**VILLAGE OF BARTLETT**

**COMMITTEE AGENDA**

Ashton Gardens Preliminary/Final PUD Plan & Special Uses

DATE: July 11, 2016  
TO: Valerie L. Salmons, Village Administrator  
FROM: Jim Plonczynski, CD Director  
RE: **(#16-05) Ashton Gardens**

FIGURE 1. Ashton Gardens – Site Plan Considerations

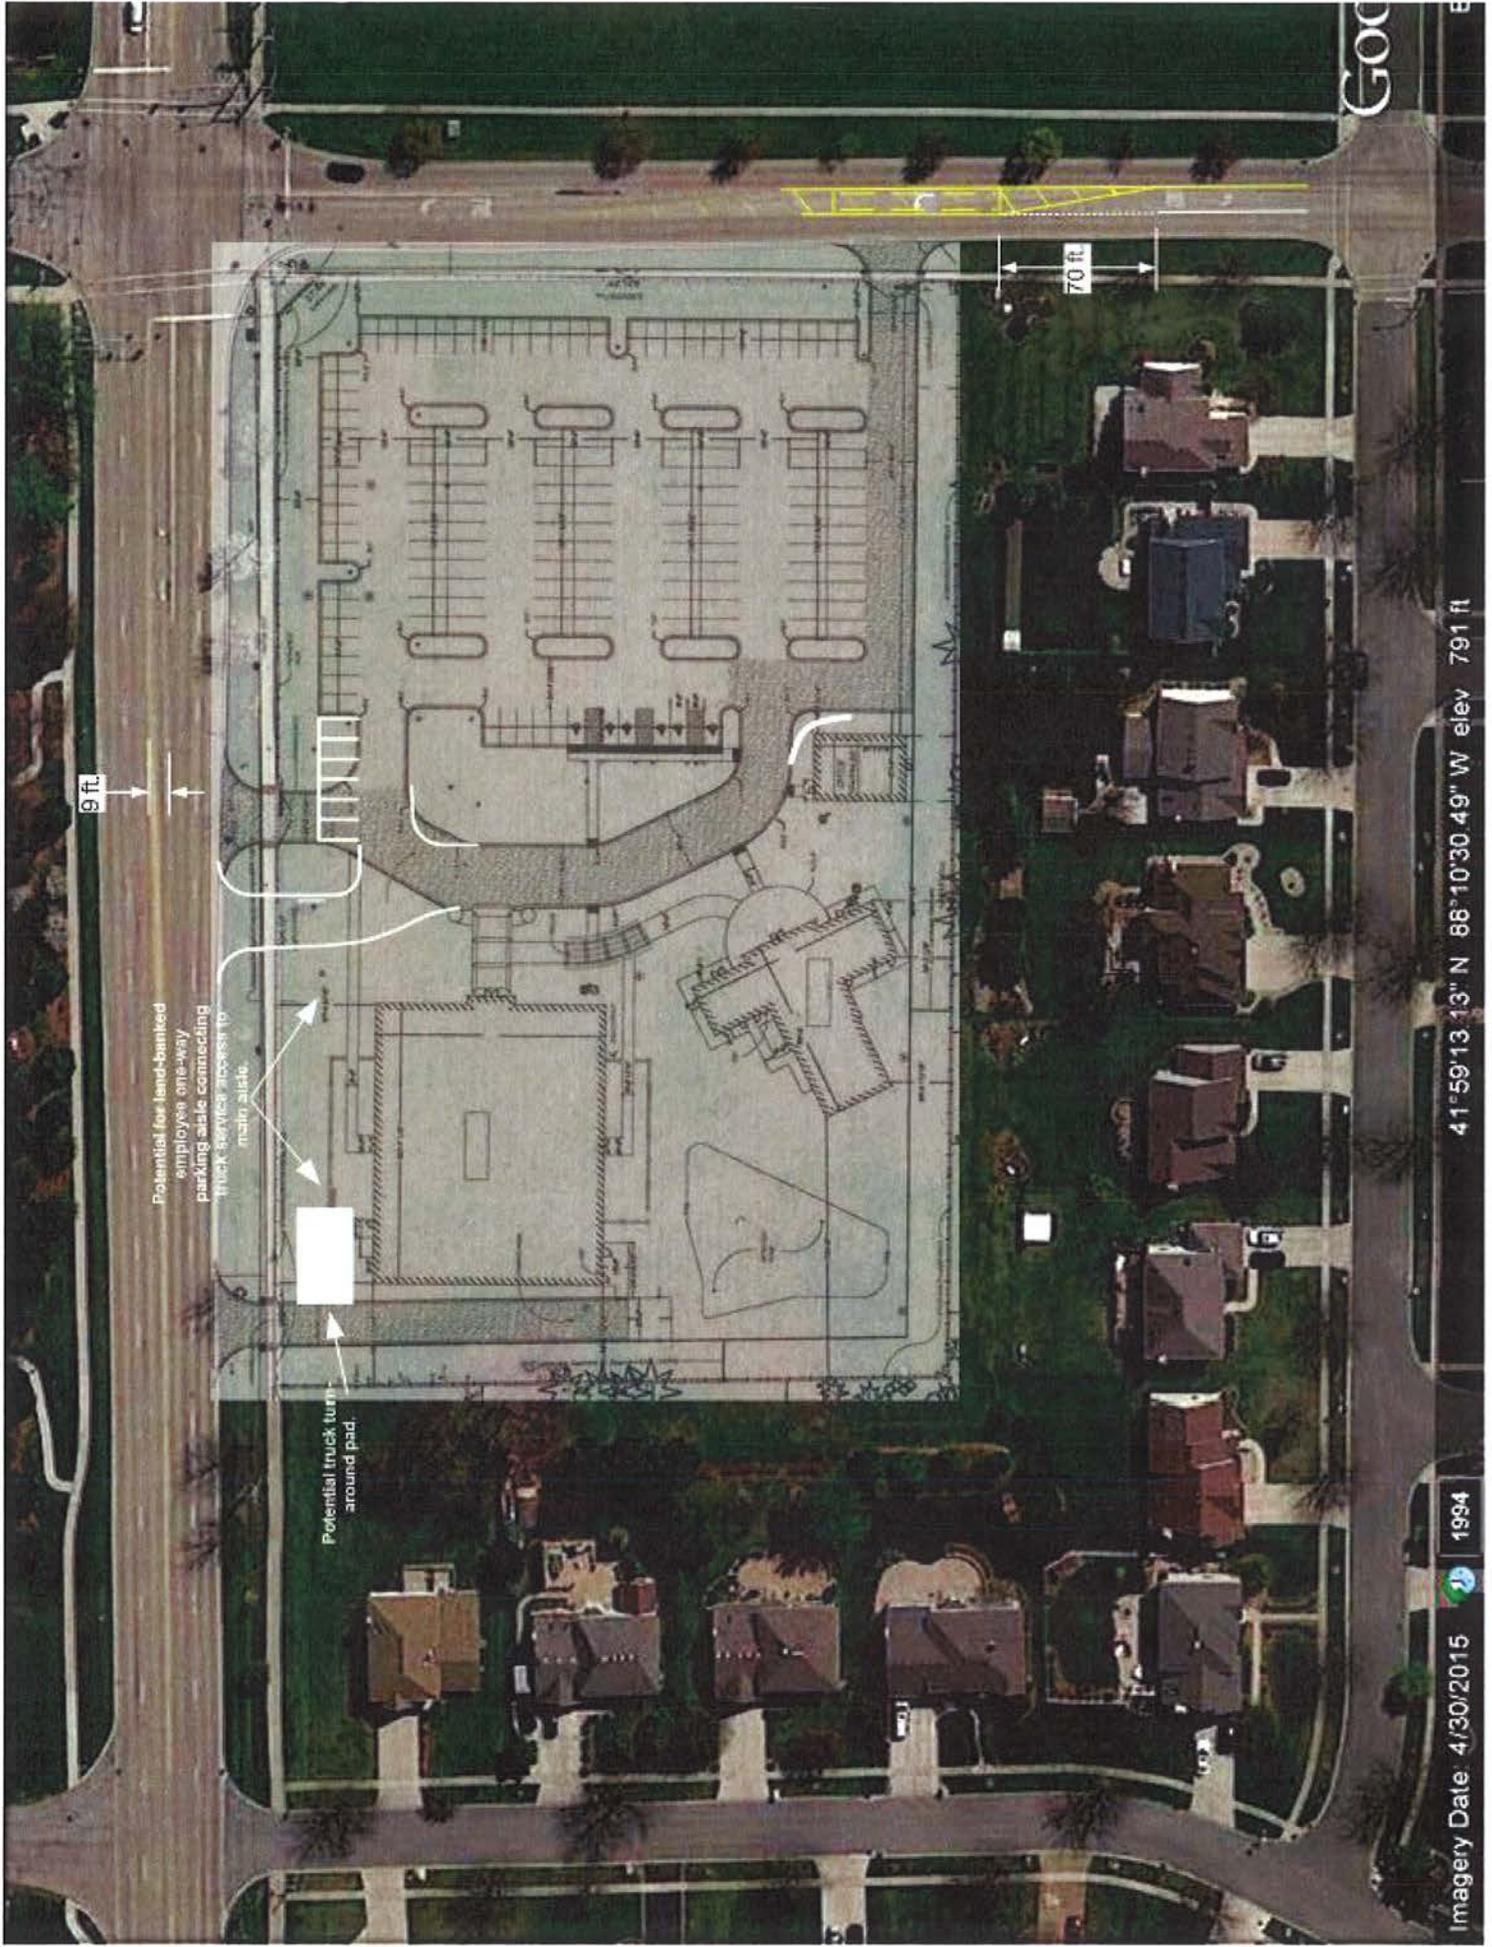
As shown in Figure 1., the Devon Avenue access is located approximately 220 feet west of Prospect and falls opposite the striped taper median area for the EB left-turn lane on Devon at Prospect. At this point the EB taper width is approximately 9 feet and in such cases there may be a tendency for WB left-turns into the site to straddle this median area as they wait to make their turn. One consideration would be to relocate this access to the west as shown in Figure 1. This could also result in the addition of +/- 6 parking spaces (see parking review that follows). In any event, this part of Devon Avenue is under the jurisdiction of DuPage County and they would have final authority on access location. Relocation of the driveway to the west also improves exiting sight lines relative to vehicle queued on red indications on Devon at the Prospect Ave. signal.

The Prospect Avenue access shown on the Site Plan falls generally opposite a diagonally striped median and beginning of a SB left-turn lane taper serving Lido Terrace. Under the same rationale as discussed above, it may be advantageous to consider restriping this median area on Prospect to provide a legal left-turn storage area for inbound site left-turns while still maintaining the SB left-turn lane (with reduced taper length) for Lido Terrace as shown in Figure 1.

A separate truck service berth and refuse truck access is provided by a separate truck-only access on the west side (rear) of the reception hall building. This would require service vehicles or fire trucks to back out onto Devon Ave., but maximizes green area on the site and separates trucks from guest traffic. A turn-around pad for smaller delivery trucks could be considered south of Devon on this service drive (see Figure 1.).

An aerial fire truck turning path exhibit was provided in support of the Site Plan and shows a vehicle just able to navigate the around the winding parking access aisle at the south end of the site near the office building. The Village should determine if this design vehicle adequately reflects wheelbase, length and turning radii of their own fire equipment. I would suggest consideration of modifying the curb line near the office building area if possible, as shown in Figure 1 (this may require some minor shifting of the office building further west).

As noted earlier an additional/ +/- 6 parking spaces if the main access drive were relocated further west and consideration of land-banked employee spaces (a one-way aisle to minimize depth) may be of interest on the north side of the building (see Figure 1.).

Consider relocating the main access on Devon further west (Figure 1.) to move it away from the EB left-turn lane entry taper on Devon at Prospect (this could also create potential for added parking spaces internally). Consider restriping the median area north of Lido Terrace to maintain the existing SB left-turn lane but add legal median left-turn storage for the proposed site access (see Figure 1.).

There is no internal connection for the rear (reception hall) loading berth. Service trucks will be forced to back out onto Devon. A truck turn-around pad could be considered near the northwest corner of the reception hall (Figure 1.).

Fire truck access through the main parking access aisle is tight. Verify that the design fire vehicle is compatible with the Village design fire truck and consider a slight modification to the curb line in the vicinity of the office building (see Figure 1.).

*Relocation of the main Devon access drive to the west would create an additional +/- 6 guest parking spaces. Land banked employee parking (one-way aisle) could be considered on the north side of the reception hall connecting the service drive to the main Devon access drive (Figure 1.).*
